Westinghouse
Electric Corporation

AW-95-903

November 17, 1995

SUBJECT: WESTINGHOUSE RESPONSES TO NRC REQUESTS FOR ADDITIONAL
INFORMATION ON THE AP600

Figure 440.346-1 CD=0.8 DBCLA Break Transient - AP600, Pump Speeds

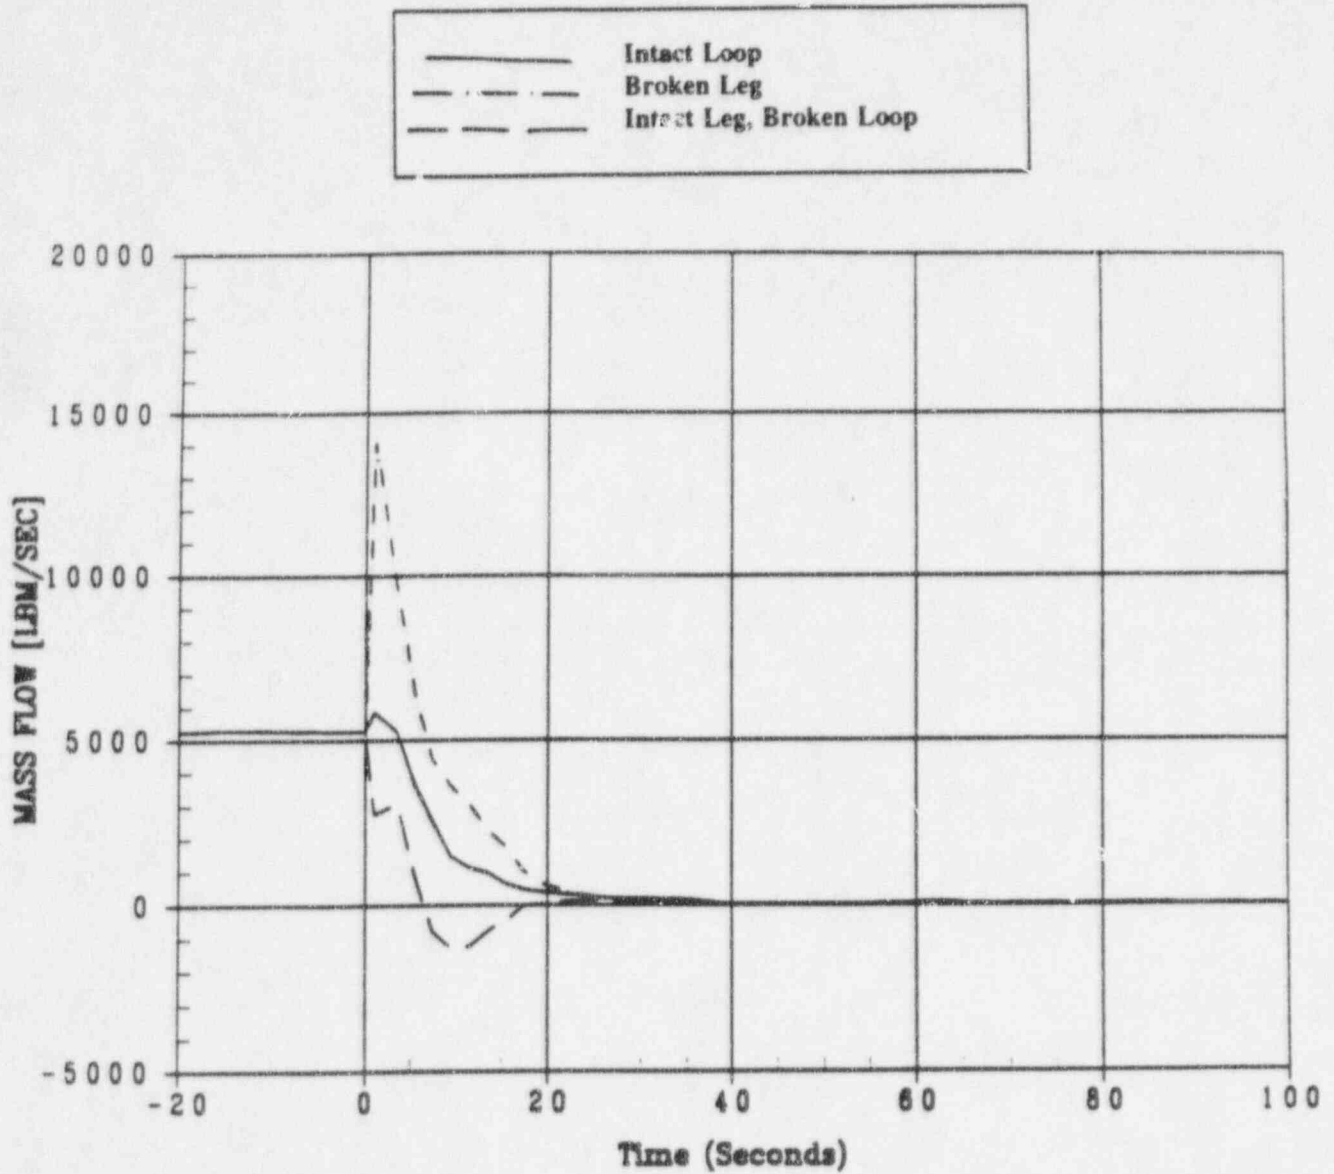
Response:

The Reference 440.346-1 SSAR large break LOCA analysis indicates that forward flow through the intact cold leg and RCP of the broken loop is maintained for the first seven seconds of blowdown, as shown for the CD=0.8 DECLG break analyzed with WCOBRA/TRAC (Figure 440.346-2). At that time voiding in the RCS degrades the performance of all RCPs (Figure 440.346-3). Flow reverses through the RCP in the intact cold leg of the broken loop to feed the break. Since the broken cold leg itself in the broken loop is no different from the broken cold leg in the more common 4 X 4 loop configuration, it is modeled in the same way as the standard Westinghouse plants. The Reference 440.346-1 analysis is therefore using a fully assessed broken loop cold leg model methodology from the CQD, and existing WCOBRA/TRAC assessments are sufficient to conclude that the code is applicable to modeling the AP600 cold leg break configuration.

Figure 440.348-19 CCTF Run 58, Upper Plenum Pressure

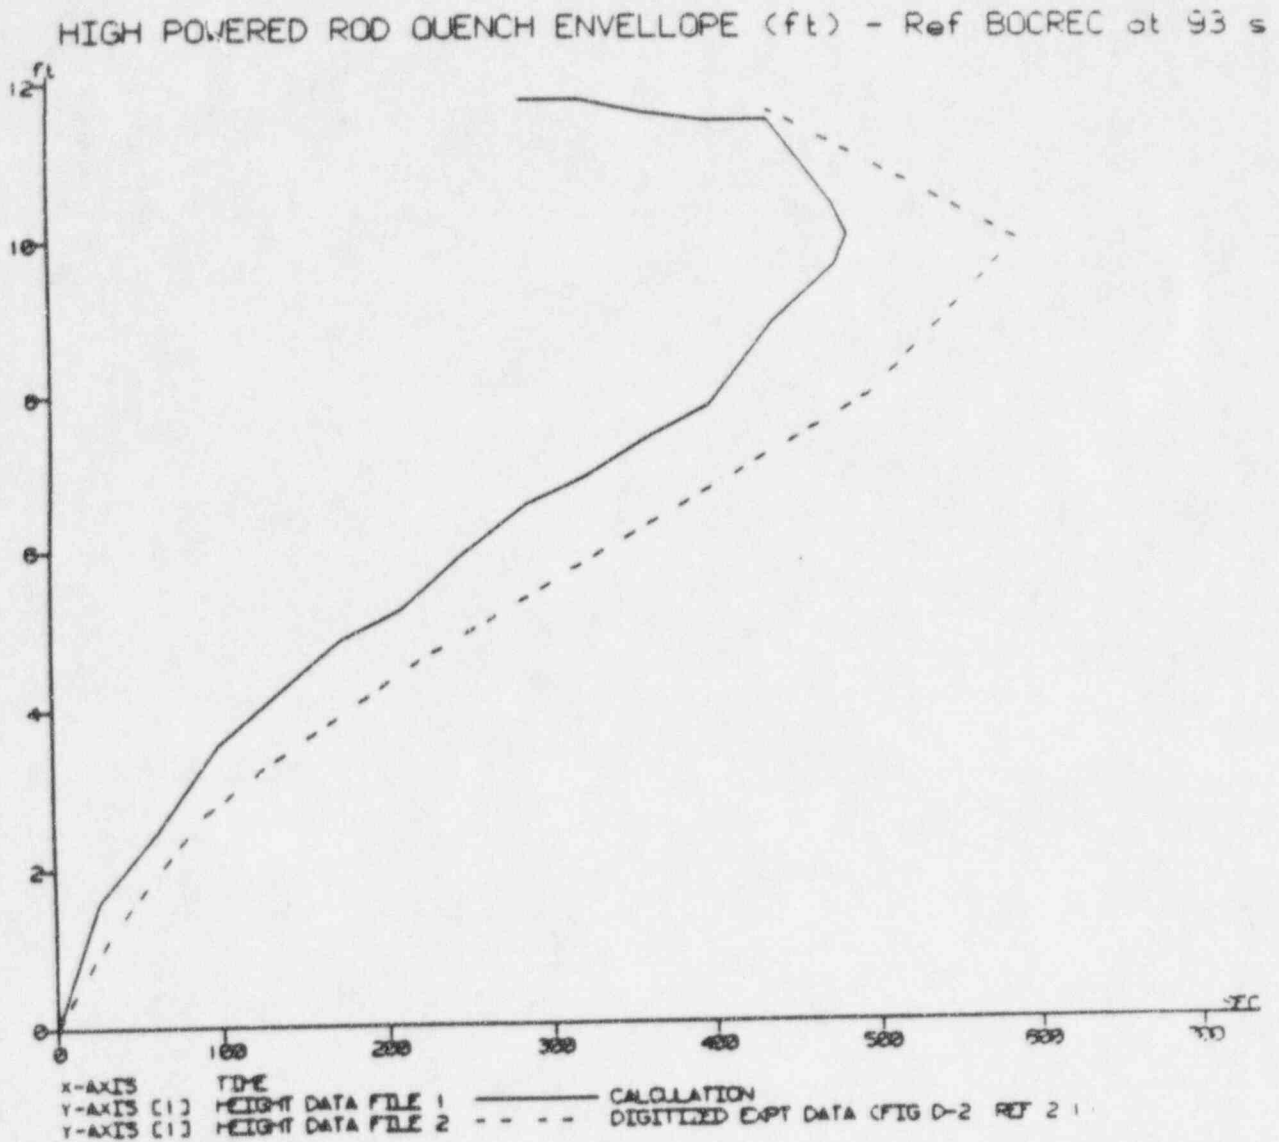
- b) Compare the WCOBRA/TRAC calculated and the experimentally measured vessel refill rates for the CCTF and UPTF tests.
- c) Analyze the baseline tests for CCTF Run 58 and UPTF Test 21 with WCOBRA/TRAC. Compare the calculated and measured results for all the tests and clarify if the trends observed in the experiments from the baseline case to the test case were properly calculated by WCOBRA/TRAC. If not, clarify why and discuss any implications for AP600 BE LBLOCA analyses.

The WCOBRA/TRAC simulation of Run 58 overpredicts the upper plenum pressure (Figure 440.348-19) because the code is removing energy at a faster rate than the test, as shown in quench front plots 440.348-16, 17 and 18. The code predicts a faster reflood than occurred in the test, but the high powered rod PCT prediction are conservatively high.
